Model	LCT / Duplex Unit for C4MF	Volt/Hz	Date of Modification	Serial Number
Modified Article	Parts Catalog			
Reason for Modification	Parts catalog correction

LCT / Duplex	Unit for C4MF		Volt/Hz	Date of Modification	Serial Number
Microswitch a	and LED Sensor Type - T				
Parts standar	dization				
rdization with	h the other products, the follo	wing parts have beer	n changed. The in	nterchangeability	is O/O.
	Description	O'tri Llood	Parts Ca	talog	
New P/N	Description	Q ty Used	Index No.	Page	
	Microswitch - AH715254N	$1 \rightarrow 0$	111	11	
12042356	Microswitch - AM51612A531	$0 \rightarrow 1$	111	11	
	LED Sensor Type - T	$1 \rightarrow 0$	9	25	
AW020041	Photointerruptor	$0 \rightarrow 1$	9	25	
	Microswitch a Parts standar rdization wit New P/N 12042356	New P/NDescriptionMicroswitch - AH715254N12042356Microswitch - AM51612A531LED Sensor Type - T	Microswitch and LED Sensor Type - T Parts standardization rdization with the other products, the following parts have been New P/N Description Q'ty Used Microswitch - AH715254N $1 \rightarrow 0$ 12042356 Microswitch - AM51612A531 $0 \rightarrow 1$ LED Sensor Type - T $1 \rightarrow 0$	Microswitch and LED Sensor Type - T	$\begin{array}{c c

DETAILS OF MODIFICATION

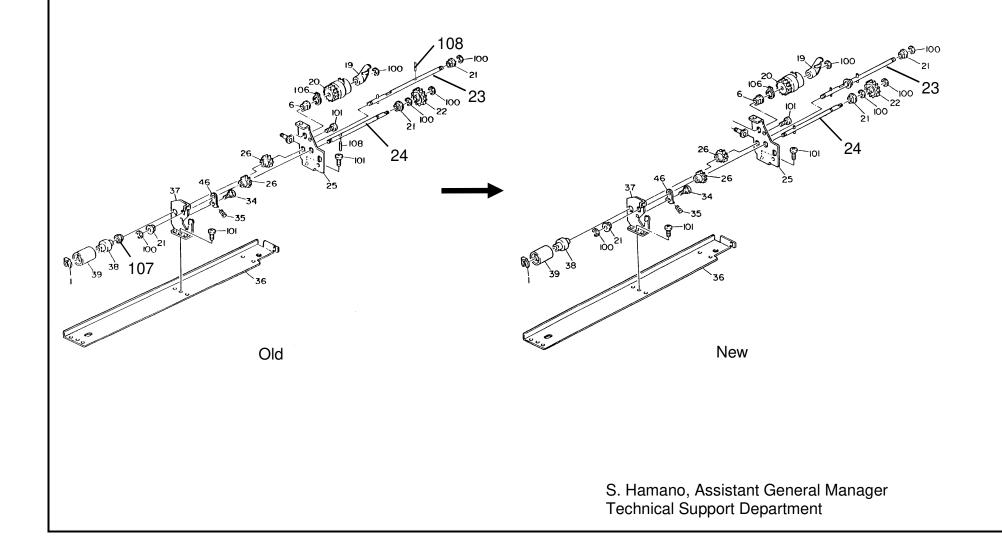
The cylindrical pins on the reverse roller drive shafts have been changed to spring pins. To facilitate servicing, the assembled parts will be supplied as service parts in stead of the individual parts as shown below.
